Planning Application
For Residential Development

Land at Moor Lane
Kirk Langley
Derbyshire

Technical Note 1
Response to DCC Highways
Comments Dated 07/10/25

November 2025

Appendix C

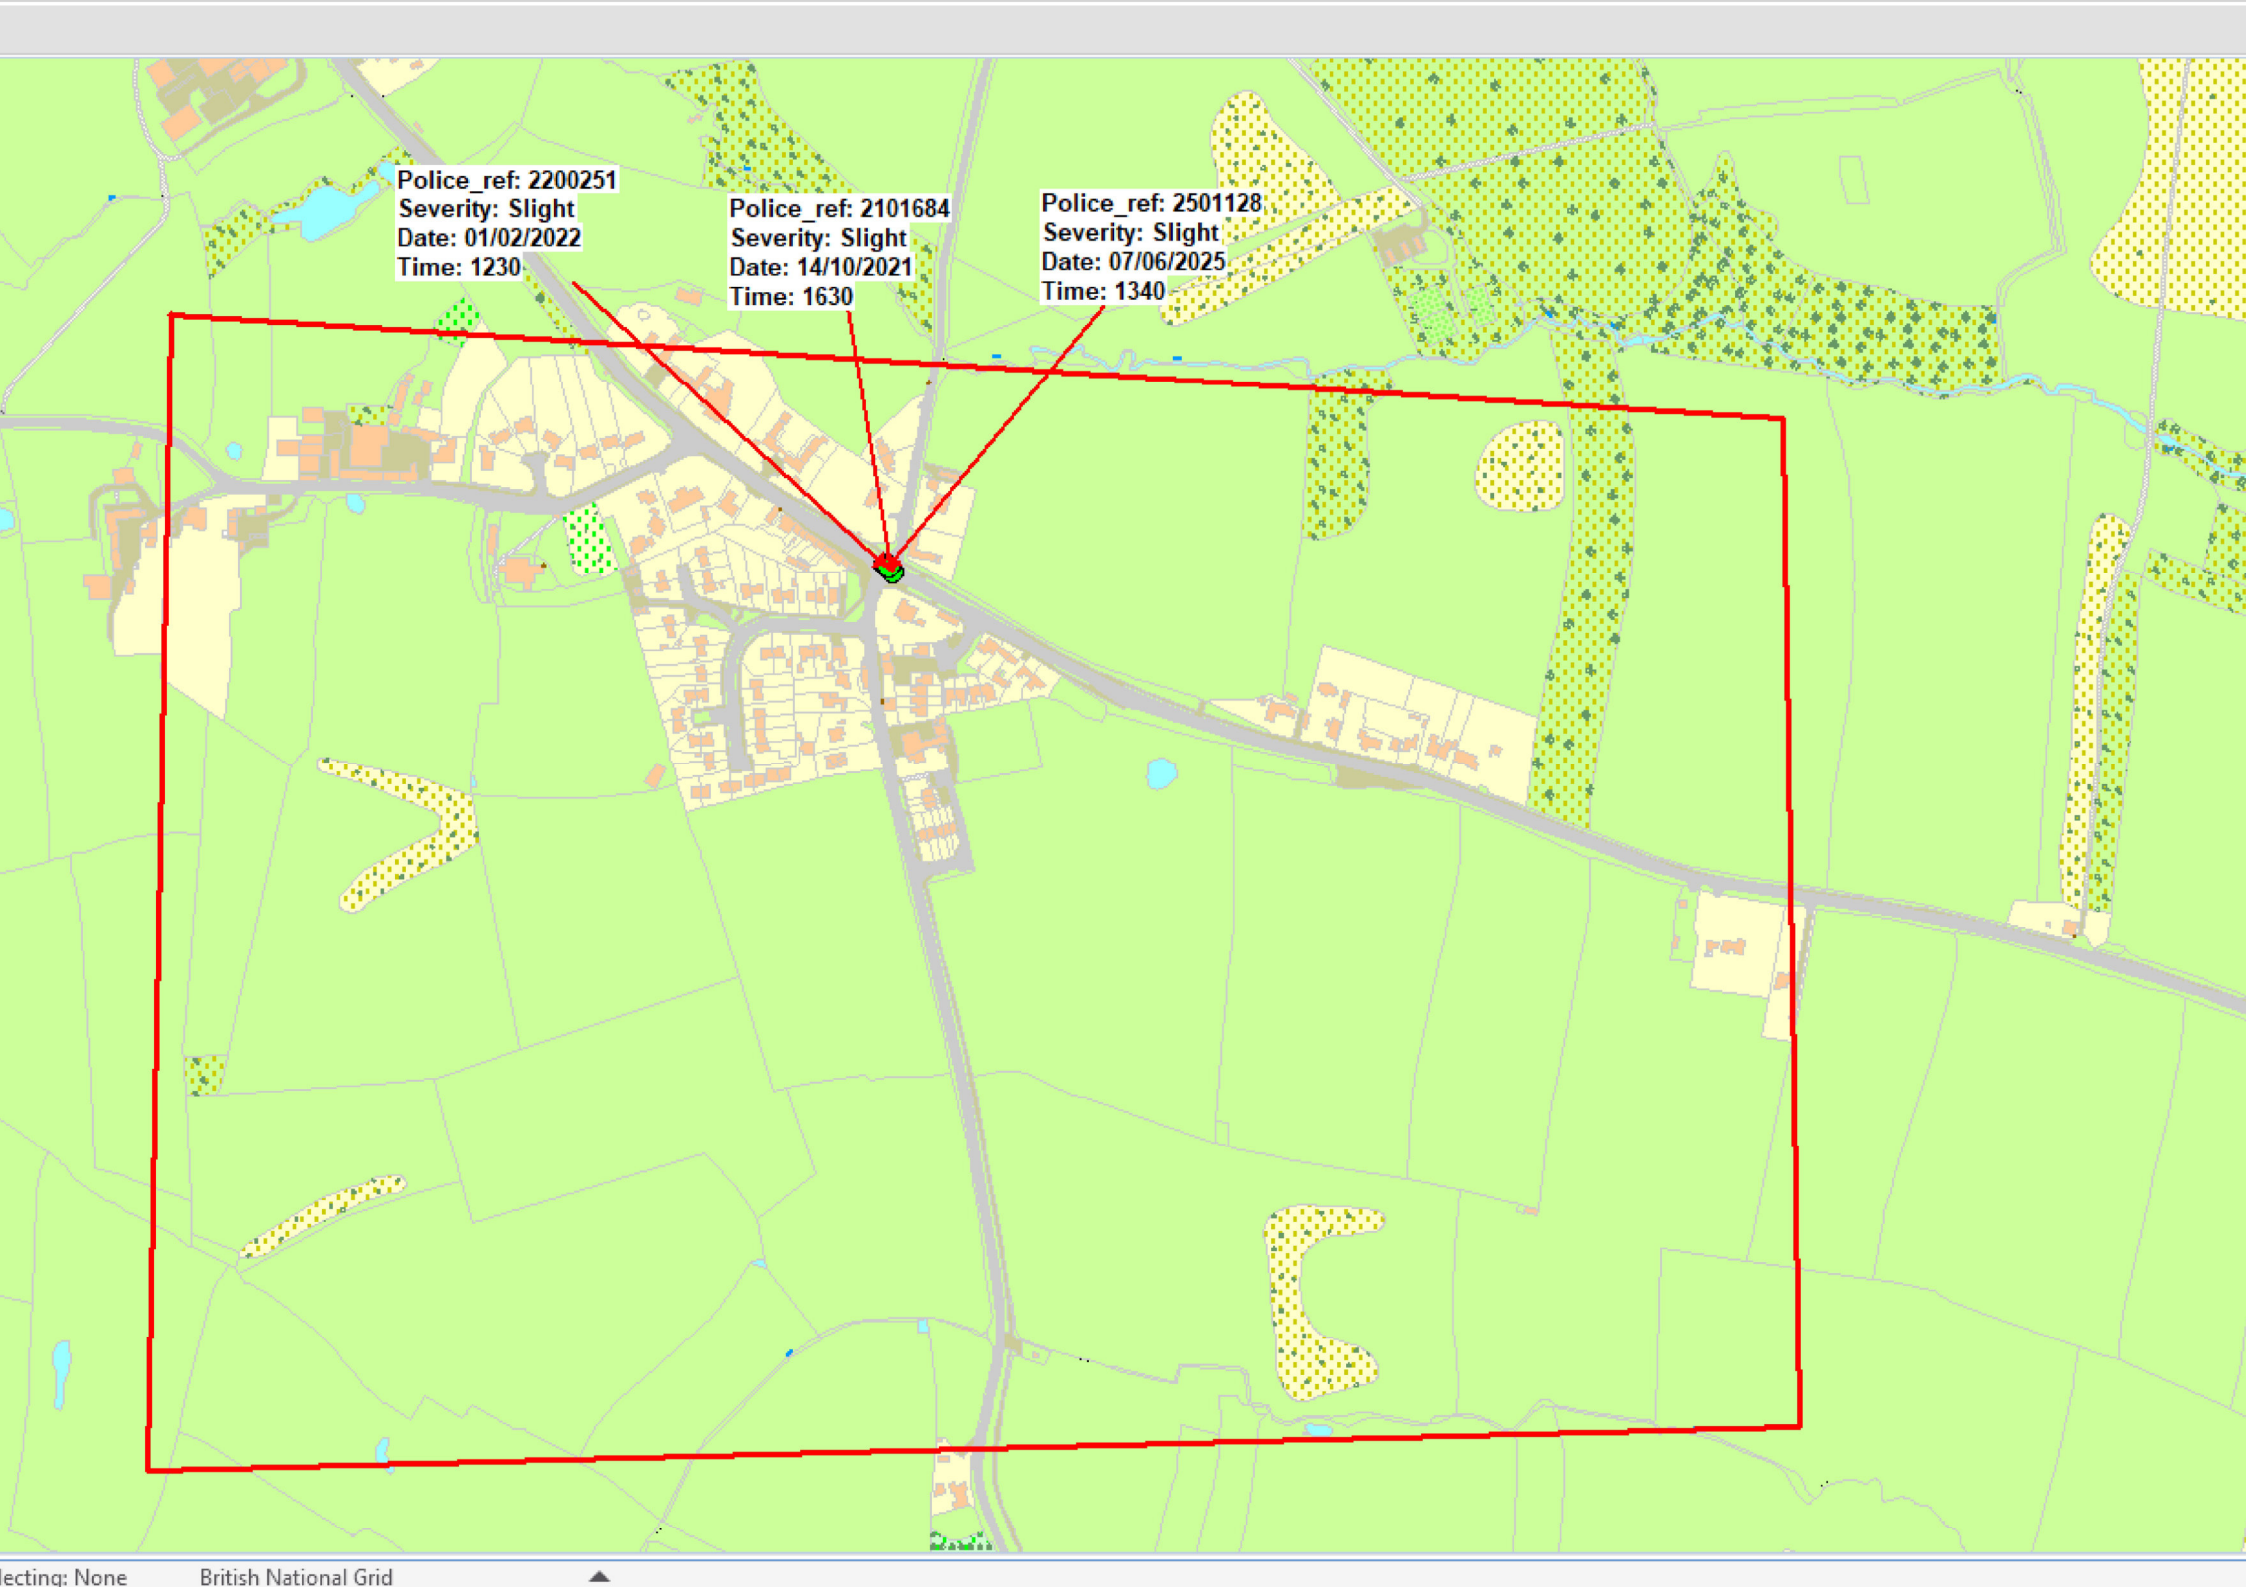
Paras 2.24 and 2.25 - the TS does not specify the period within which accident data has been obtained. However, "Crashmap" accident data is routinely out-of-date, and the earlier part of the assessment period will span periods of Covid19 lockdown. Up-to-date accident data should be analysed within the TS study area and can be obtained from DataQualityRRD@Derbyshire.Police.uk. Accident causation/conflicts should be analysed.

PIC accident data for the most recent 5 year period available has been obtained from Derbyshire Police. The data and accident plots can be seen at Appendix C of the TN. The submitted TS investigated an accident study area involving Moor Lane to the north of the site and its junction with the A52. Using data from Crashmap the TN identified that no accidents were recorded at Moor Lane with 2 'slight' accidents recorded at the A52 junction. A review of the data obtained from Derbyshire Police confirms again that no accidents were recorded at Moor Lane with 3 'slight' accidents at the A52 junction. All three accidents involved vehicles turning right from the A52 into Moor Lane but only involved slight injuries. The TS via detailed peak hour capacity assessments demonstrated that the Moor Lane / A52 junction will incur a negligible impact resulting from development traffic. The TS conclusion that the development will not be detrimental to highway safety therefore remains valid in light of the updated accident analysis.
